WESTBERG + WHITE, INC.
ARCHITECTS AND PLANNERS

January 20, 2014

Subject: **ADDENDUM to Pre-Design Assessment Report
For the New Cuyama Pool Incident Reconstruction Project
290 Wasioja Street, New Cuyama, Ca 93254**
County of SB – P.O. #CN15986
County of SB Project No. 8736 NCPI
W+W Project No. 13032

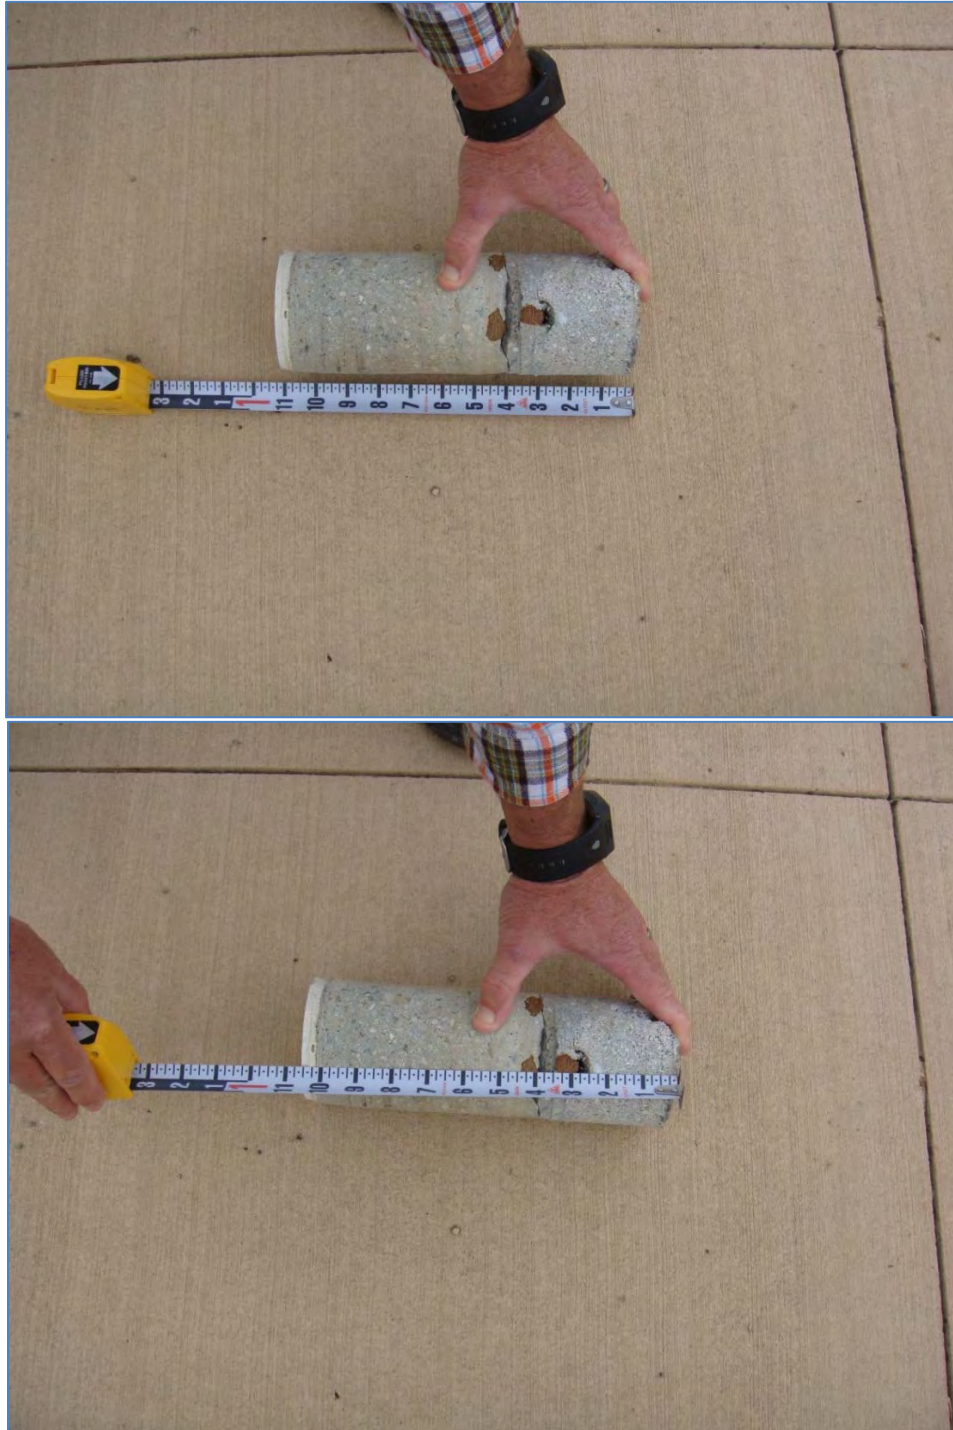
5. The wading pool has a diameter of 22 feet (22') and ranges in depth from 12 inches (12") to 18 inches (18") (See Figure 4).
6. When we first approached the pool area, it was obvious that the wading pool had suffered massive differential settlement. The deck around the wading pool had settled at a different rate from the wading pool; the wading pool coping had separated from the wading pool (See Figure 5). The wading pool's bond beam was cracked.

Figure 7: Photo of Schedule 80 PVC pipe put in by the pool contractor.

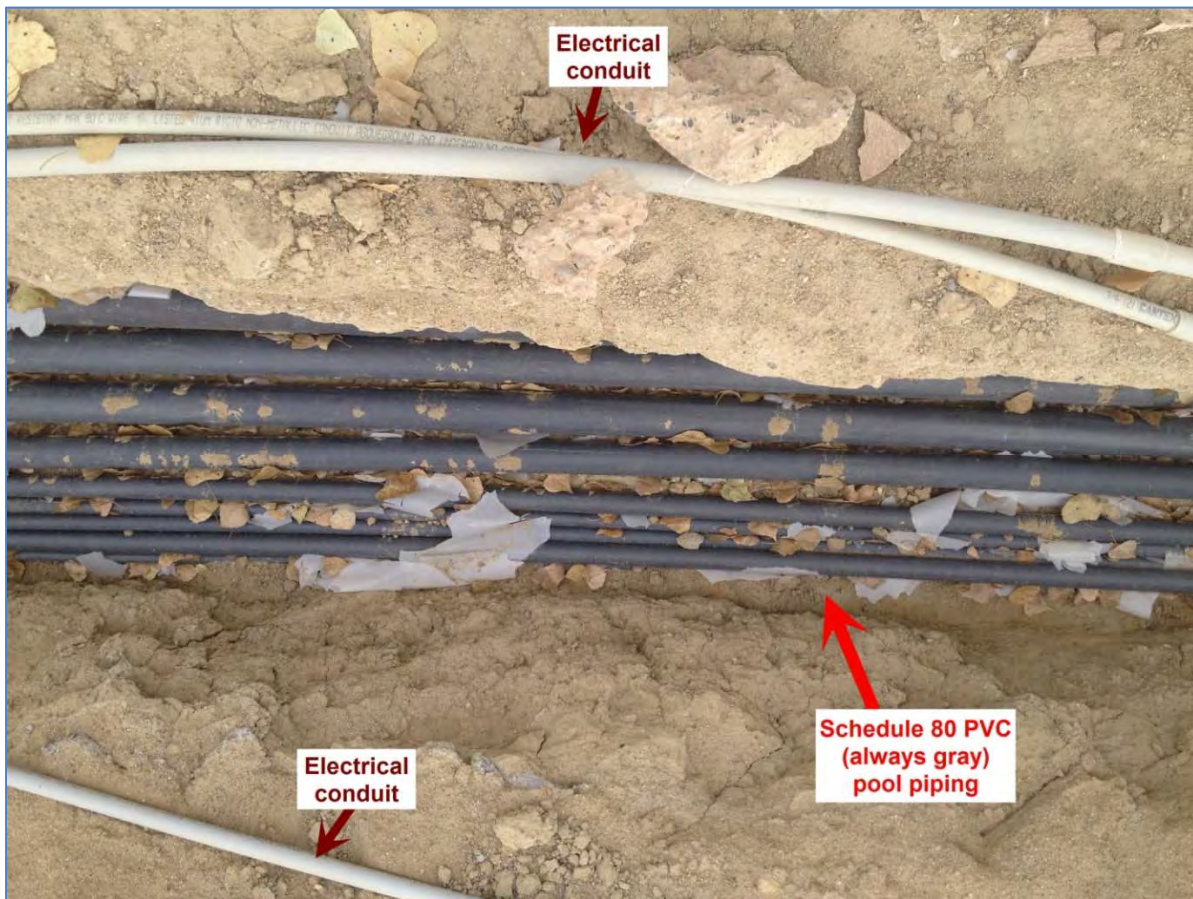
7. Due to the exposure of some of the piping, we were able to determine that the pool contractor utilized Schedule 80 PVC (max working pressure 400 lbs.) for the pool piping (See Figure 7), which is much stronger and more durable than the Schedule 40 PVC pipe (max working pressure 240 lbs.) specified in the drawings. Schedule 80 PVC pipe has approximately 40% more wall thickness than Schedule 40 PVC pipe. The tensile strength of all PVC is 7,300 psi.

Figure 23: Diagram of the elevation measurements taken around the wading pool at the Rowley International site inspection on December 18, 2013.

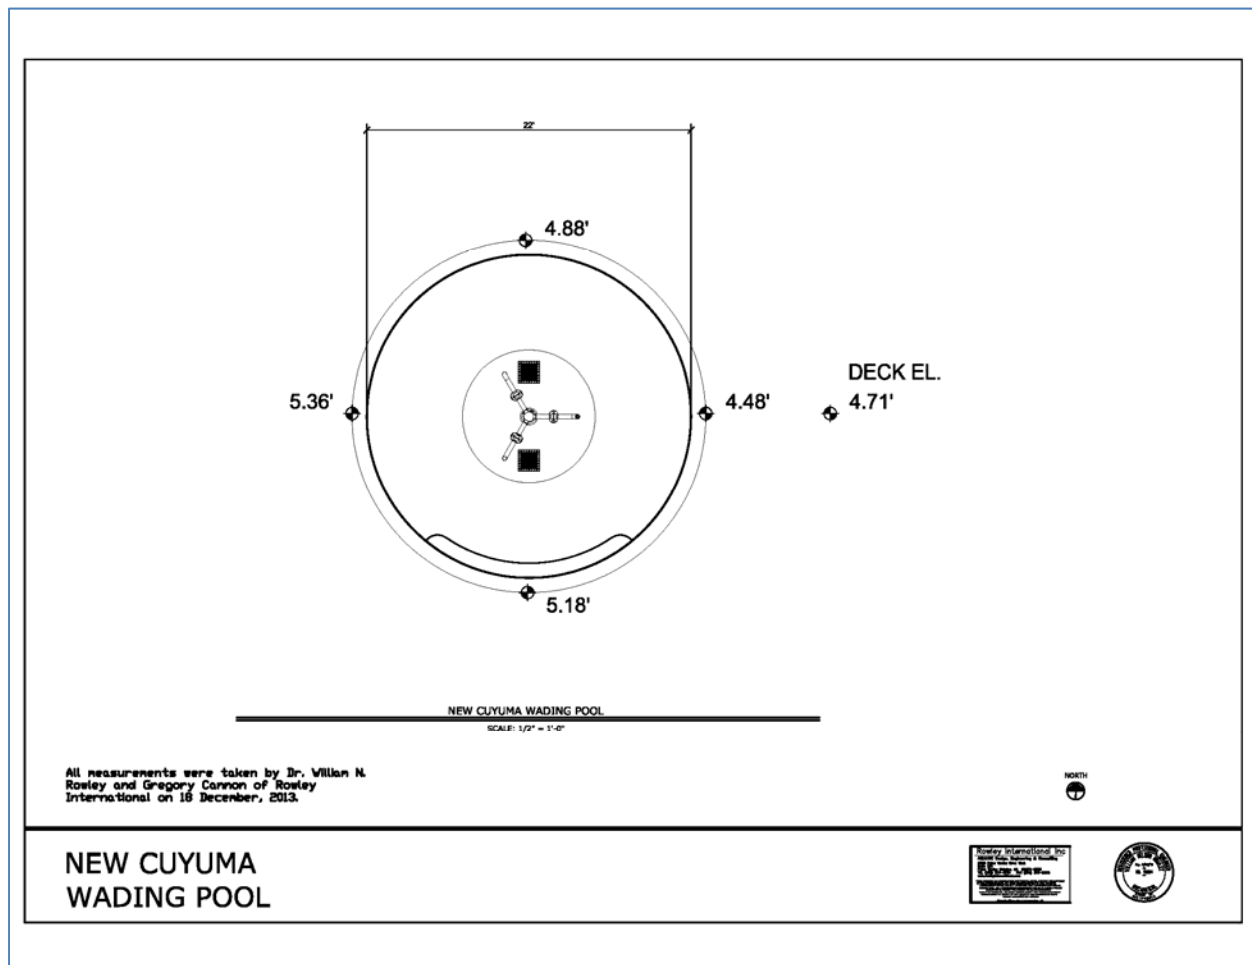
12. We took four elevation measurements around the wading pool, one in each quadrant (See Figure 23). The measurements showed that greatest difference (5.36 feet minus 4.88 feet) was 0.48 feet (0.48'), or approximately 6 inches (6"), which is consistent with the amount of deck settlement at the corner of the building (See Figure 27). The wading pool at its highest point (these measurements were off the coping) was 4.88 feet (4.88'). Its lowest point was 5.36 feet (5.36').

Figure 26: Elevation measurements taken around the swimming pool at the Rowley International site inspection on December 18, 2013.

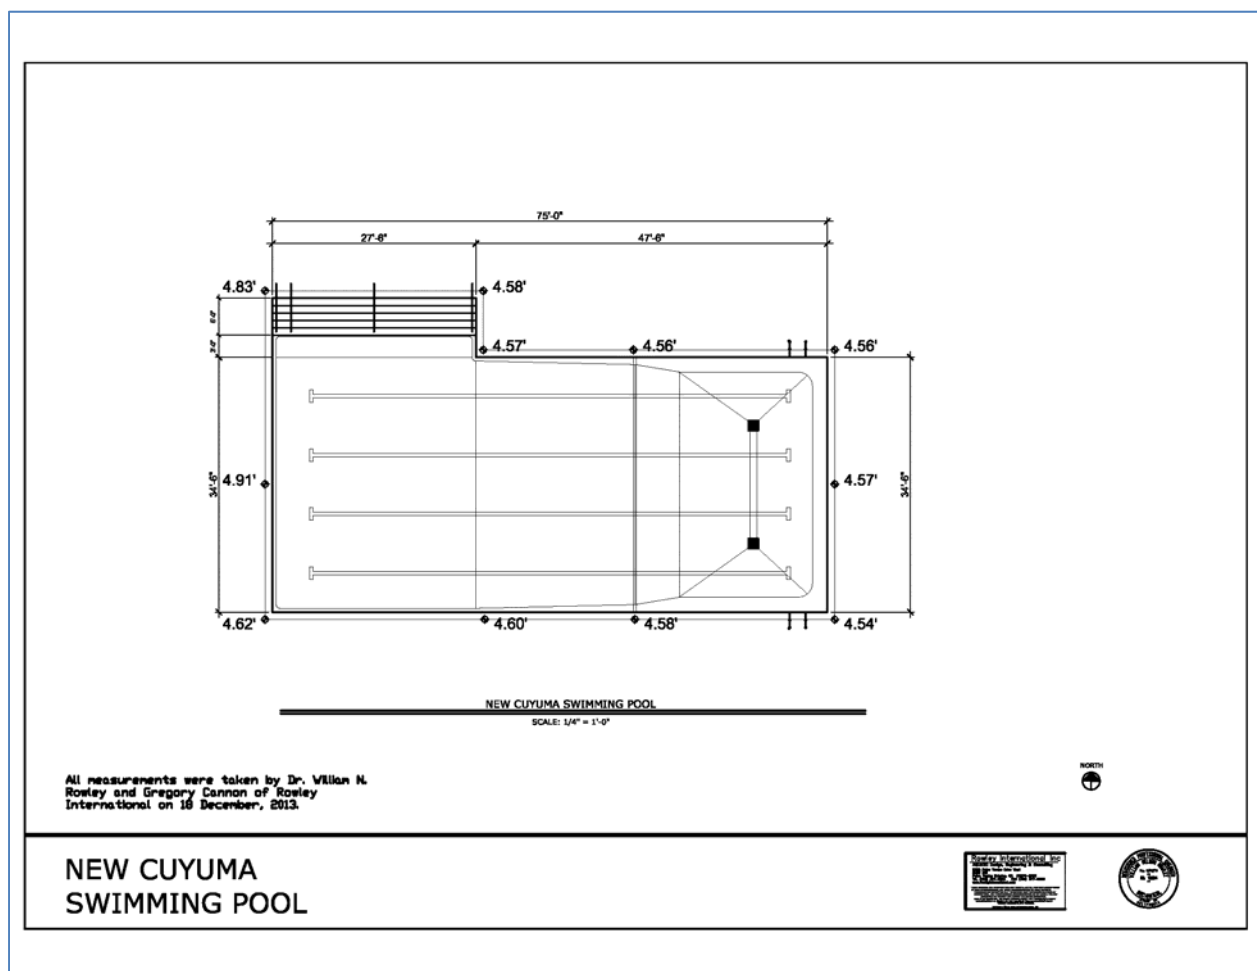
13. We took eleven level measurements around the swimming pool on the pool coping (See Figures 24-26). We determined that the difference in elevation between the highest and lowest corners (4.83' minus 4.54') is 0.29 feet (0.29') or 3.5 inches (3-1/2"). We surveyed the elevation of the northwest corner of the swimming pool (the lowest corner and where the most differential settlement or subsidence occurred) and found it to be 4.83 feet (4.83'). We surveyed the southeast corner of the swimming pool (the highest corner) and found the elevation to be 4.54 feet (4.54'). This is the second-worst case of differential settlement I have seen in a pool in 50 years of practice.

15. As shown above, we measured differential settlement in the swimming pool from the northwest corner to the southeast corner to be 3.5 inches (3-1/2"; See Figure 26). **The swimming pool has continued to settle further than indicated by the waterline witness mark.**

16. The northwest corner of the swimming pool is currently 3.5 inches (3-1/2") below the southeast corner of the swimming pool (See Figure 26). Swimming pools are designed so that the skimmers normally operate with the water level halfway up the 6-inch (6") skimmer throat. In this method, the skimmers are operated with a plus-or-minus-3-inch (± 3 ") margin of safety (i.e., the pool water level can increase or decrease up to 3 inches (3") without affecting skimmer operation). This is no longer the condition of the swimming pool.

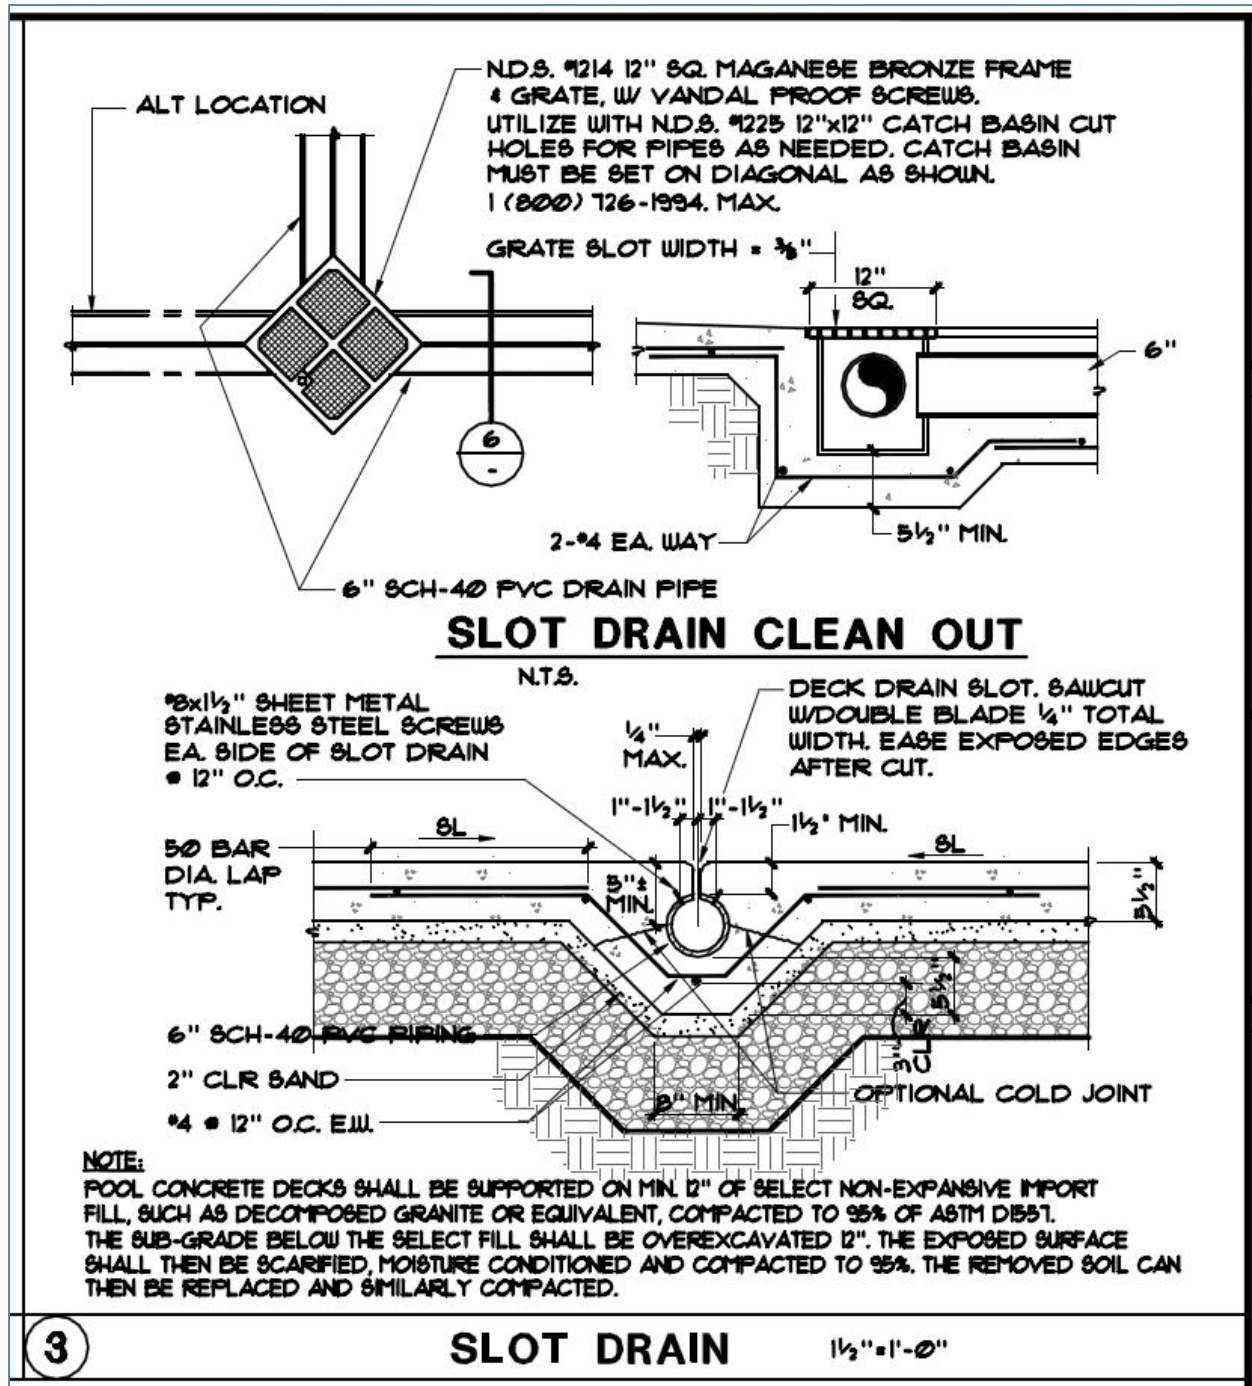
28. It appears that, for whatever reason, the contractor did not follow the design drawings with regard to the deck drainage system (the deck slot drain and slot drain clean out). Drawing SP-15 Detail 3 required Schedule 40 PVC pipe (which is always colored white) for the deck slot drain (See Figure 37). The type of piping used for the deck slot drain was not the required Schedule 40 PVC, but some kind of green thin-walled piping that is much thinner than Schedule 40 PVC (See Figures 38, 39).

- a. 5.5 inches (5-1/2") of concrete was not emplaced under the slot drain clean out as required by Drawing SP-15 Detail 3 (See Figures 37-39).

- b. Drawing SP-15 Detail 3 required that reinforcing steel/rebar be placed around the slot drain clean out; there was none placed where the drawing required (See Figures 37-39).
- c. Electrical conduit was run through the space that should have had, per Drawing SP-15 Detail 3, concrete and rebar (See Figures 37-39).

30. It also appears that, for whatever reason, the contractor did not follow the design drawings with regard to the deck drainage system (the deck slot drain and slot drain clean out). Drawing SP-15 Detail 3 required that the pool concrete decks be supported on a minimum of 12 inches (12") of select non-expansive import fill such as decomposed granite or equivalent. As shown below, the fill used for that location was likely derived from materials excavated on-site, which was not equivalent to the required fill (See Figures 37, 40).

Fig. 3 Example Manufactured Slot Drain system – Zurn Z888 - 4HD (HDPE)

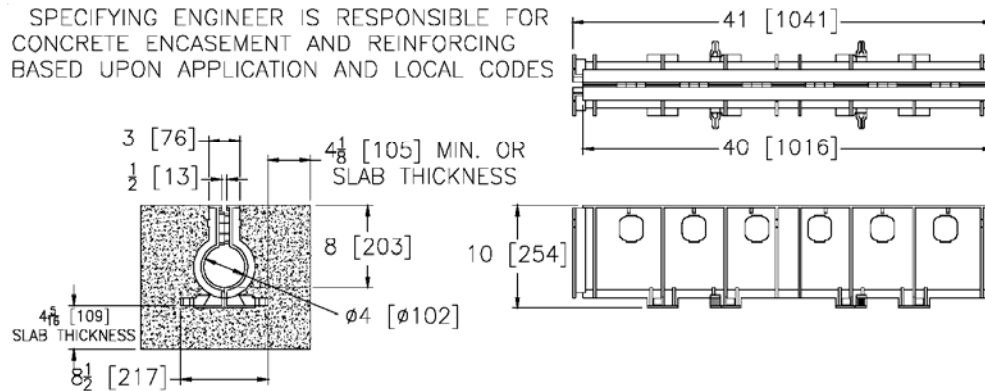
- a. Slot drain detail 3/SP-15 in reference AC-FRD, is not well sealed against leakage and water may have leaked out between the concrete and the outer surface of the PVC drain pipe in part due to the expansion index differential of the materials and in part due to the 2-way saw-cutting of the deck and pipe below. It may also have leaked through the rough surfaces of the "optional cold joints" within the underlying slab (Photo No.12).

- f. Replace all existing deck area field fabricated slot drains with new water tight manufactured HDPE types, such as the Zurn product shown in Fig.3, with stainless steel grates, sealed joints, and connect to the new cleanout and drainage inlet boxes.
